October 20, 2021

The following addresses items concerning excess clay material available at the Admin Building Bus Lot that could potentially be utilized for the Capron School project. The contractor estimates approximately 1,354 cubic yards of excess clay material available. This material can either be hauled to fill site or to the Capron School for no price difference. If this material is to be utilized at the Capron School, the geotechnical testing agency will need to determine if this material is usable. There is a possibility that only a portion of the material will be usable. The geotechnical testing agency will also need to determine if this material will be usable for the parking lot and detention basin berm, or if the material is only usable for the berm. The amount of material needed for the detention berm is similar to the amount available the Admin Building Bus Lot. It is anticipated if there is extra material that the berm height can vary to accommodate any excess material.

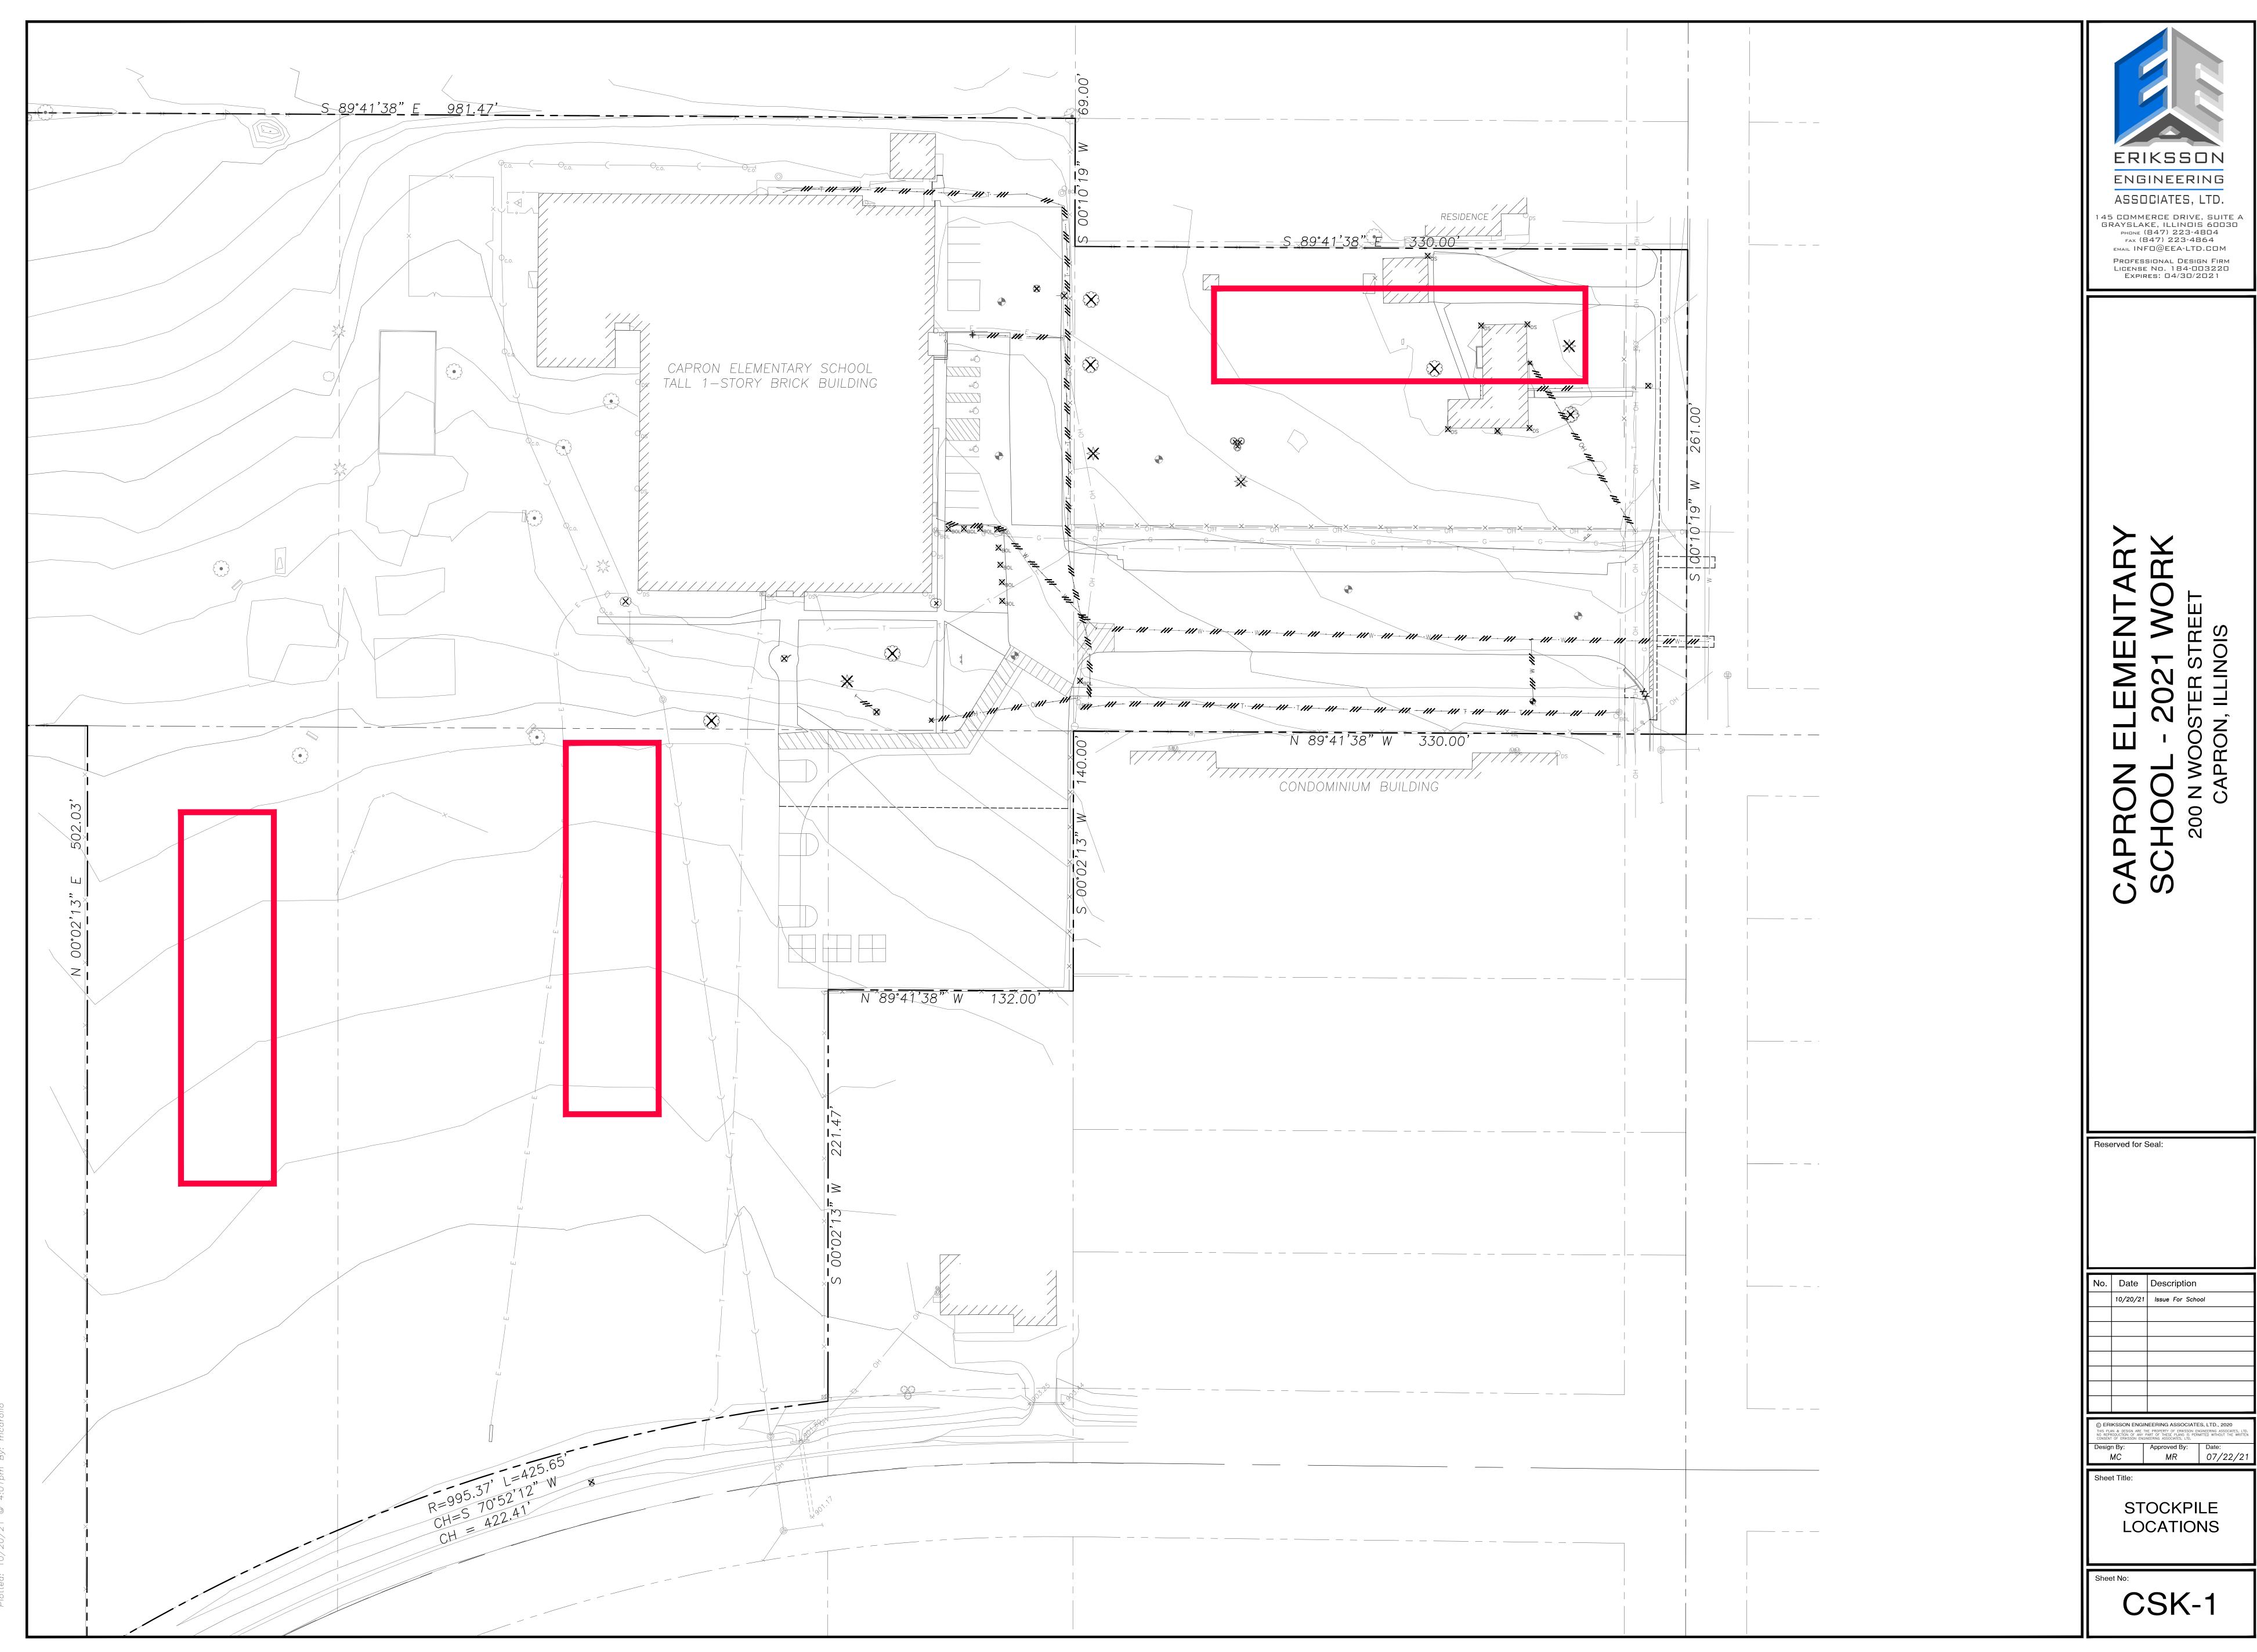
There multiple locations for the potential stockpile at Capron with items to consider for each. One location, which was recommended by the contractor, would be located on the lot purchased by the school where the building was demolished. This area would be at the front of the school and very visible to the public. This location is also the furthest from the detention basin area where the material will be utilized. This location will not require the contactor to traverse through the school to drop off the material for the stockpile. The other 2 locations are located to the west of the playground area. These locations are closer to the detention basin berm area and are not as visible of locations. These locations will require the contractor to traverse through the school lots and onto the playground area to create the stockpile. This may cause damage to the playground pavement. The northernmost 40' of the playground area are being removed with the proposed project. Therefore, if the contractor can remain on the northernmost 40' of the playground, this pavement will end up being removed. The rest of the playground work is an alternate and may not be done in the project next year. See exhibit for markup of suggested locations.
